No.: 05 TS – 47Rev
May 19, 2006

SUBJECT: **MBE 900 EGR Temperature Sensor**

Figure 1 EGR Temperature Sensor

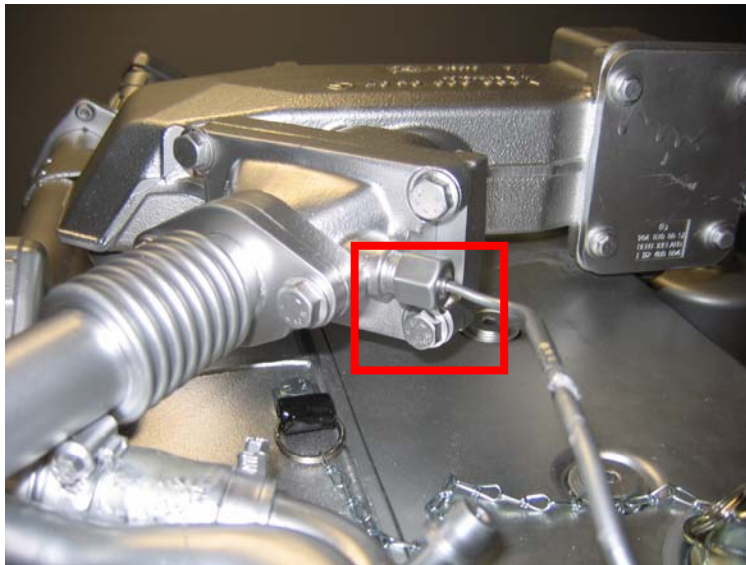
EGR Temperature Sensor failure resulting in one or more of the codes below:

- EGR System-Temperature Above Normal (SID 146, FMI 0)
- EGR System-Temperature Below Normal (SID 146, FMI 1)
- EGR System-Bad Component (SID 146, FMI 12)

The EGR Temperature Sensor has been eliminated since September 7, 2005, effective with engine serial number 515294.

Faulty EGR Temperature Sensor.

Do NOT replace the sensor. Reflash the PLD to turn off the sensor (refer to figure 2).

Whenever an EGR temperature sensor fails and code SID 146, FMI 0, 1 or 12 is logged, perform the following repair procedure (See Figure 1).

1. Confirm the sensor is at fault by following the troubleshooting steps for SID 146 in the *MBE900/4000 EGR Technician's Guide (7SE940)*.
2. If the sensor is at fault, do NOT replace the sensor. Leave the electrical harness connected to the sensor.
3. Reflash the PLD to update the fuel map which will turn off the sensor (Refer to Figure 2).
